GE Hitachi Nuclear Energy

Subject: Public Meeting - License Renewal Application for Vallecitos Nuclear Center

GEH Presentation on Vallecitos Nuclear Center License Renewal Application

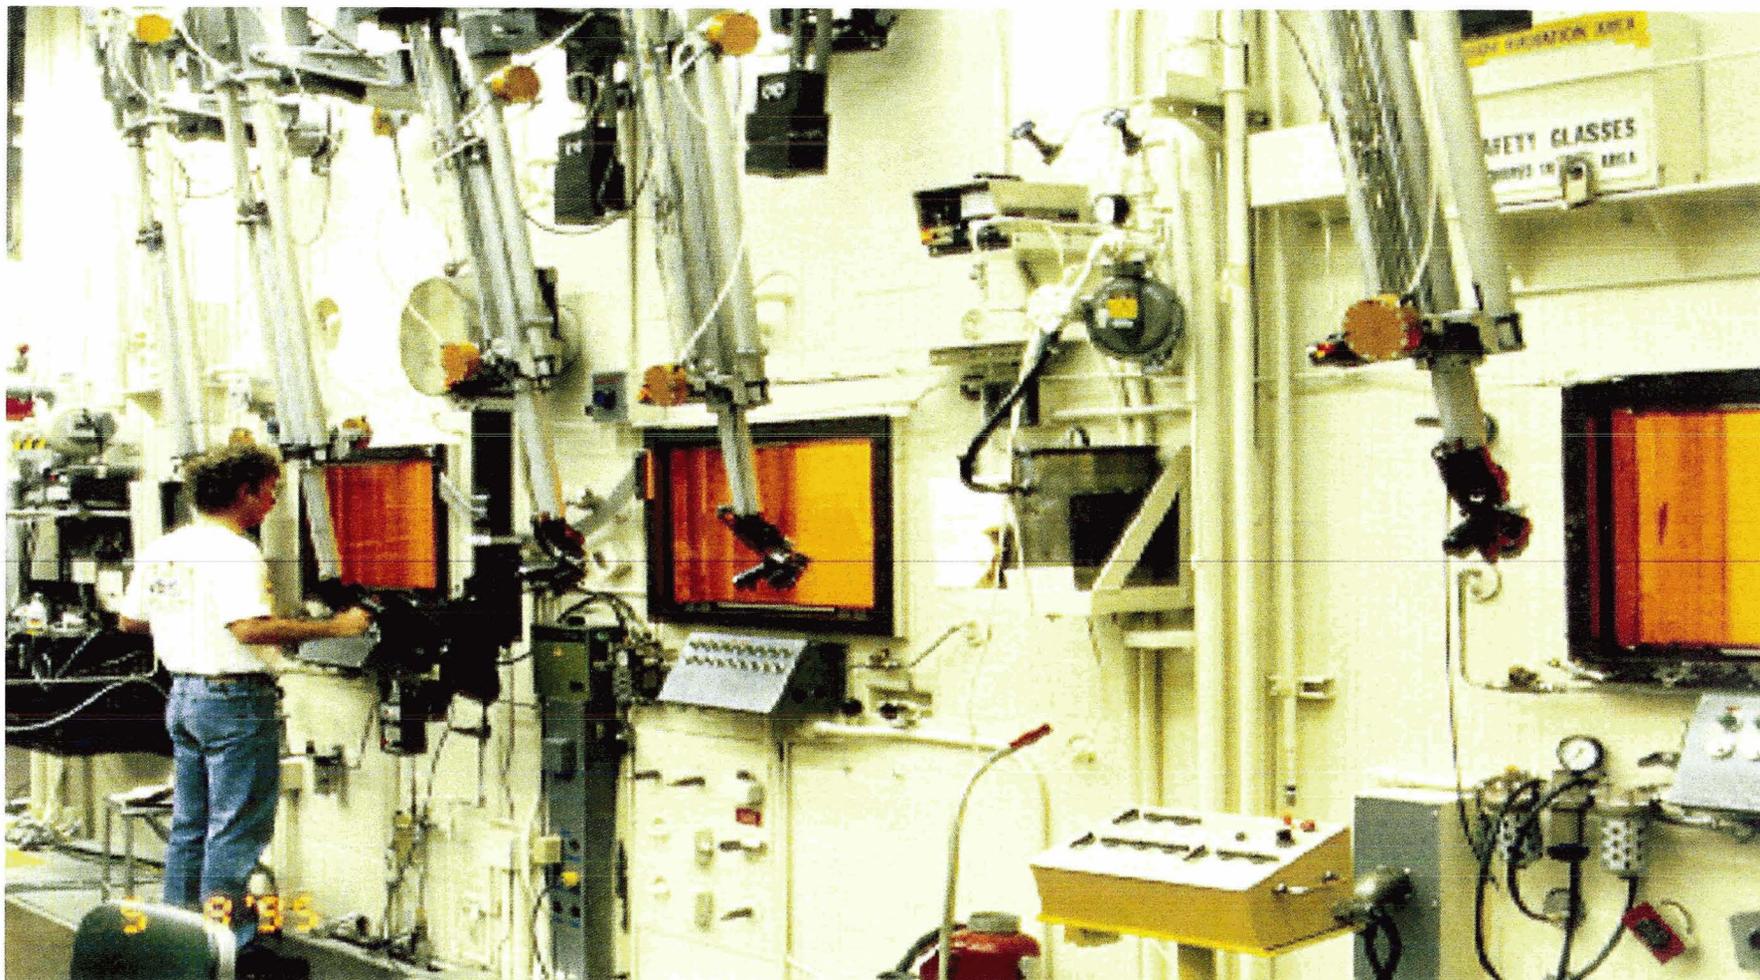
- Figures are often defined as “typical” - send pictures

- Figures are to be revised to remove clutter and highlight those features used to meet 70.22(a)(7)
- Photographs will be included to highlight some of the key items of interest
- Example photos follow
